RE: RESPONSE TO SUBMISSIONS - CAMDEN MEDICAL CAMPUS - SSD_7387

Response to Agency Submissions

Camden Medical Campus Authority Comments – Civil and Traffic

Shadow impacts from planning control building envelope

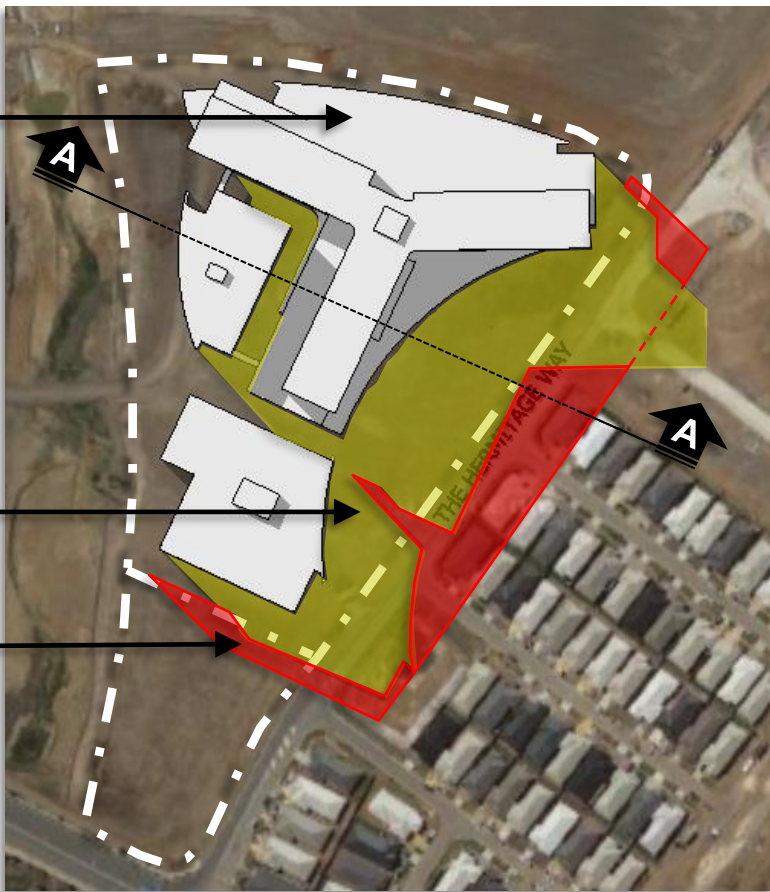
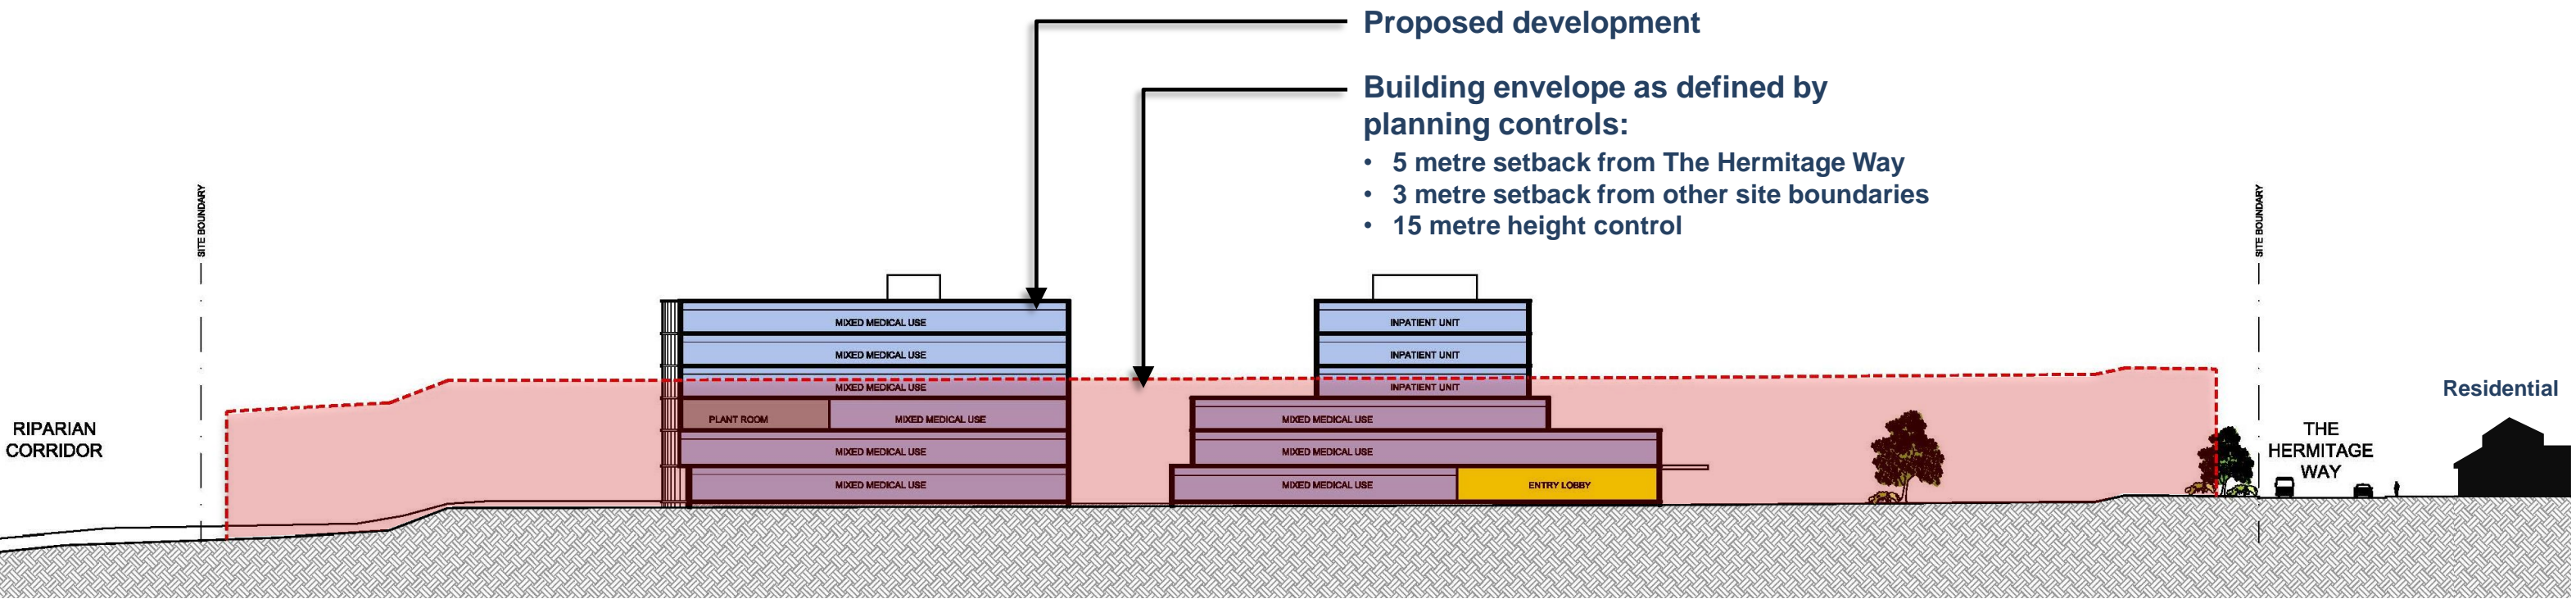
<p>Department of Planning and Environment</p>	<p>The Department requests detailed shadow analyses are provided to accurately assess potential overshadowing and solar access impacts due to increased building heights on the established residential housing to the east. The shadow analyses should include a variety of potential future building designs, including positioning of the building on the far eastern extent of the compliant building envelope.</p>	<p>CPSD sought further clarification on this matter from the DPE given consent is not sought for a building envelope on the far eastern extent of the "compliant building envelope" shown in the shadow analysis purely as a basis for comparison between impacts ("compliant" vs. proposed shadows).</p> <p>The DPE confirmed that it simply requires confirmation that any future development able to be constructed within the proposed building envelope would not deny adjoining or adjacent residential properties an acceptable level of sunlight to their existing living areas or areas of private open space. The EIS addressed this in detail in Section 8.3.2.</p> <p>In summary, we note that the mid-winter shadow analysis prepared confirms that there will be some minor overshadowing to the riparian zone and to the south of the site (which is the site of a future health services facility) in the morning, and some minor overshadowing to the residential uses to the east of the site at 3pm. However, the extent of overshadowing at 3pm is minimal and does not affect any private open space. Refer to the figure below.</p>  <p>WINTER SOLSTICE 3PM</p> <p>Despite this, all areas surrounding the site benefit from no overshadowing for the majority of the day between 9am and 3pm in mid-winter. Given the scale of the development, it would be expected that some overshadowing would occur, but this overshadowing has been able to be minimised due to the substantial setbacks of the taller components of the built form.</p> <p>We also note that the comparative shadow analysis undertaken at 3pm (refer Appendix 7) demonstrates that the shadow cast by the proposed building envelope is less than what would be cast by a fully compliant building envelope (which complies with the SEPP height standard and building setback requirements to The Hermitage Way under the Turner Road DCP).</p>

Shadow impacts from proposed development building envelope

*Shadows shown here are taken at 3pm, Winter Solstice
